# TECHNICAL BULLETIN

**[Issue No.]** T08-0008

**[Title]** Addition of CC-Link System Remote I/O Net Mode

**[Relevant Models]** AJ61BT11, AJ61QBT11, A1SJ61BT11, A1SJ61QBT11

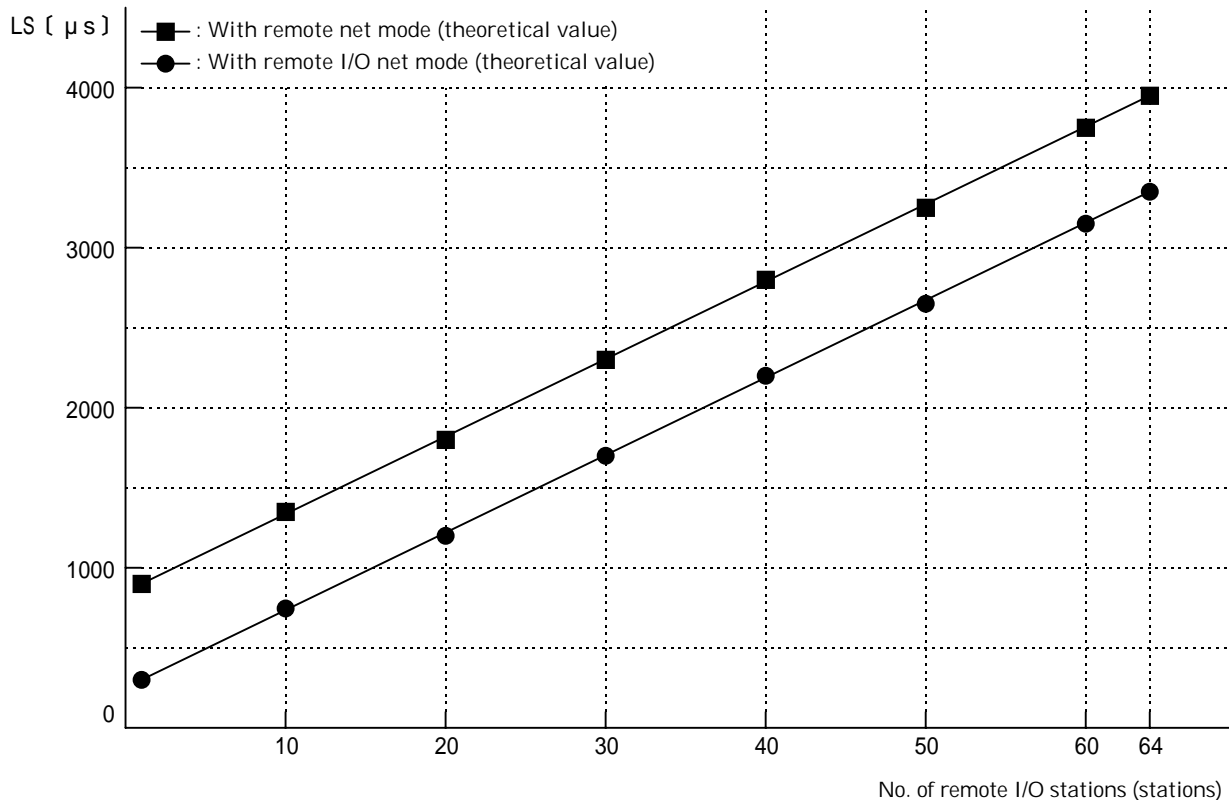
The difference in the link scan time between remote I/O net mode and remote net mode (conventional mode) is shown below.
